# Access Compliance Report

## Public Rights-of-Way

### (Curb Ramps)

Intersection ID: 14237	Main Street: BASCOM_ST	Cross Street: LABURNUM_AV	Location:	W
ADA ID: EF0ECE583084	Ramp Type: Perp	Initial Pass/Fail: Fail	Overall Compliance: No	Severity Score: 1.25

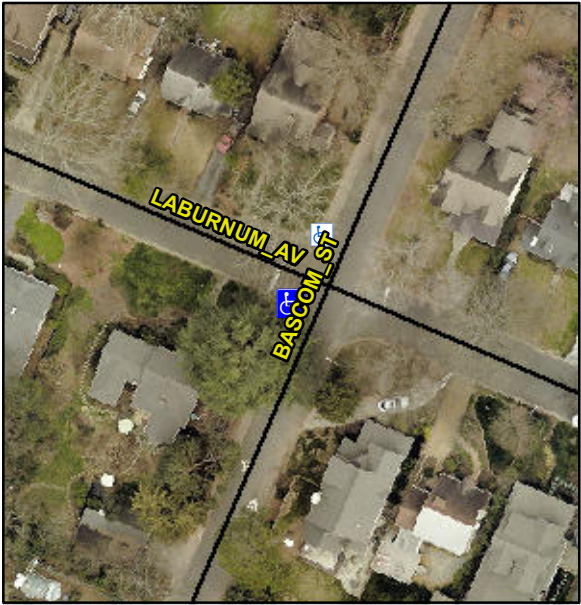
Codes/Mitigation Info/Possible Solution			Field Measurements/Component Compliance		
	Possible Solutions:		<b>Compliance</b>	<b>Description</b>	<b>Data</b>
	<b>Remove &amp; Replace Entire Ramp.</b>		<b>Yes</b>	Ramp Length (in)	60.0
			<b>No</b>	Ramp Width (in)	50.0
			<b>N/A</b>	Flare Type LT	N/A
			<b>N/A</b>	Flare Slope LT (%)	N/A
			<b>N/A</b>	Flare Traversable LT?	N/A
			<b>N/A</b>	Landing Length (in)	N/A
			<b>N/A</b>	Landing Width (in)	N/A
			<b>N/A</b>	Landing Slope (%)	N/A
			<b>N/A</b>	Landing X Slope (%)	N/A
<p>Surveyor Notes:</p> <p><b>N/A</b></p> <p>PROW/ADA:</p> <p><b>Not Found, R304.5.3</b></p>			<b>N/A</b>	Flare Type RT	N/A
			<b>N/A</b>	Flare Slope RT (%)	N/A
			<b>N/A</b>	Flare Traversable RT?	N/A
			<b>N/A</b>	DWS Provided?	N/A
			<b>N/A</b>	DWS Contrast?	N/A
			<b>N/A</b>	DWS Length (in)	N/A
			<b>N/A</b>	DWS Full Width?	N/A
			<b>N/A</b>	DWS Offset (in)	N/A
			<b>N/A</b>	Shared Landing?	N/A

<b>N/A</b>	Gutter Ponding?	N/A
			<b>N/A</b>	Gutter Lip Ht (in)	0.5
			<b>No</b>	Painted X Walk1?	N/A
				X Walk 1 Direction	To NE
			<b>N/A</b>	X Walk 1 Width (in)	N/A
				X Walk 1 Slope (%)	2.3
				X Walk 1 X Slope (%)	3.0
			<b>N/A</b>	Ramp inside XWalk1?	N/A
			<b>N/A</b>	Road Slope (%)	N/A
			<b>N/A</b>	Road X Slope (%)	N/A
			<b>N/A</b>	Any Obstructions?	N/A
				Obstruction Type	
			<b>N/A</b>		
			<b>N/A</b>		
			<b>Yes</b>	Surface Condition? (G/P)	Good
